2.5 Rooftop Plant

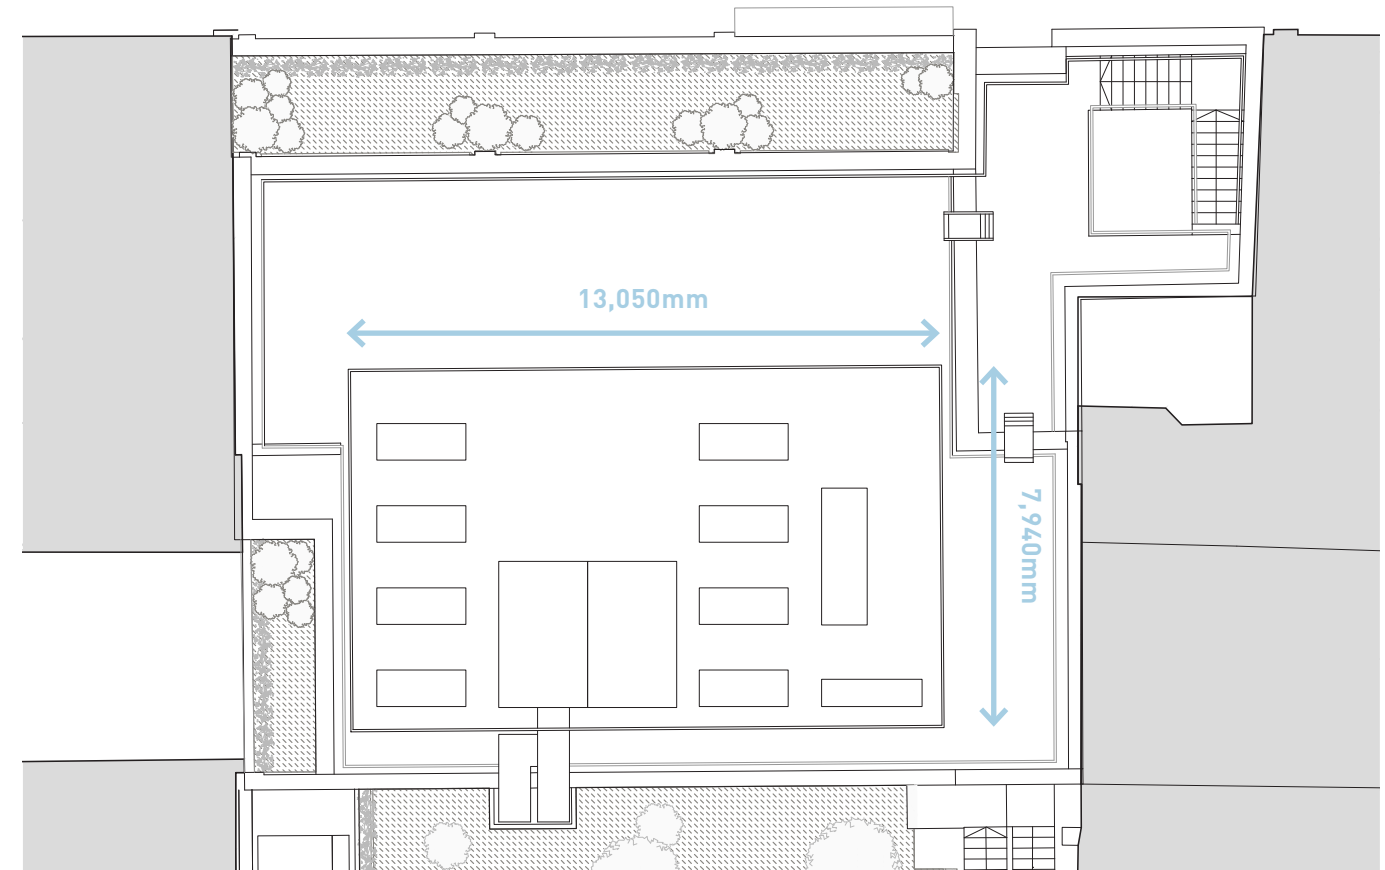
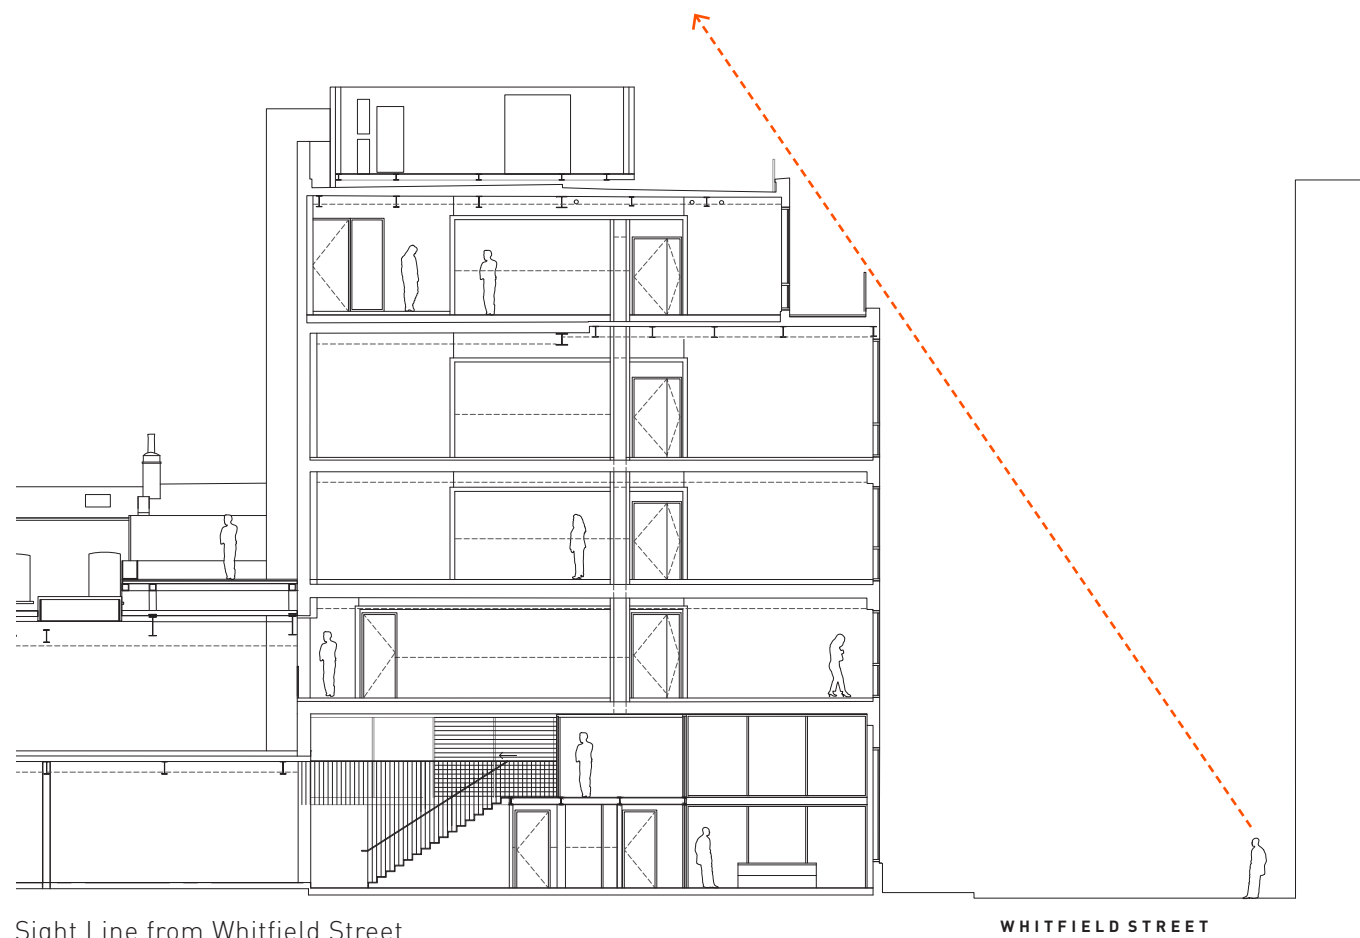
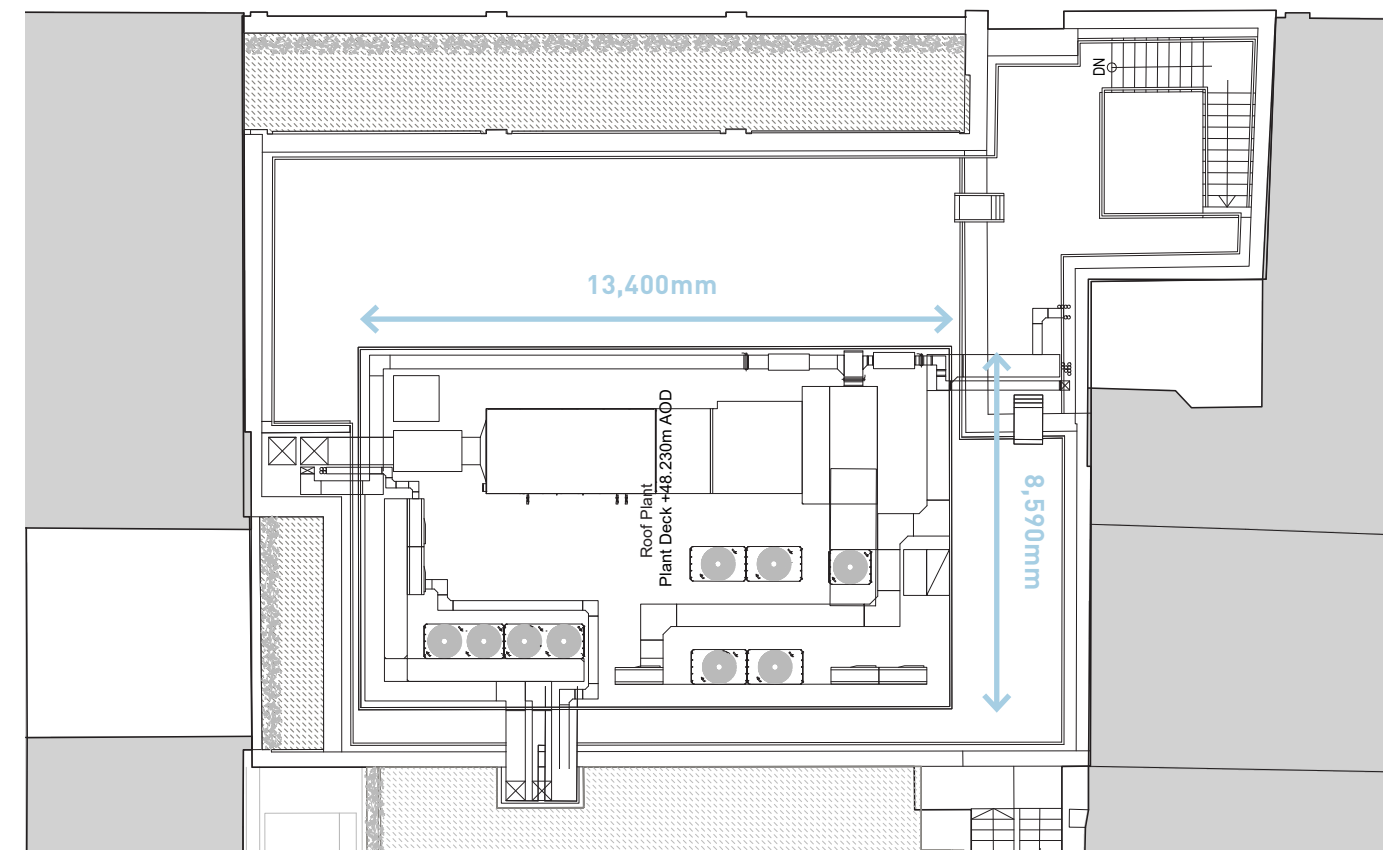
Further development of the arrangement of plant equipment at roof level has resulted in a number of units protruding above the level of the consented plant screen.

The proposed amendment looks to increase the height of the screen to completely conceal the plant equipment and to marginally alter the dimensions in plan in order to accommodate the required noise attenuation as illustrated on the adjacent drawings.

The screen will fully conceal all roofplant from the street and from the upper levels of neighbouring buildings.
